SPECIAL AIRWORTHINESS INFORMATION BULLETIN

No. CE-03-03 October 9, 2002

Fire Protection – Preventive Actions for Enhanced Fire Protection

Additional Measures Fire Protection S10/ S10-V

Picture 2-1 "Assembly on the Center Wing"

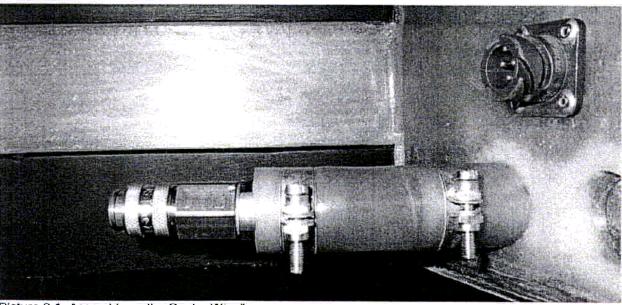
Thereafter open the clamps on the inner root rib and remove the complete hose including the quick-connector. The coarse filter inside of this hose must be removed, cleaned and finally placed in the corresponding pre-assembly of the modification set. The assembly must now be adapted to the inner wing and than tightened by use of clamps (M448, see picture 2-1)
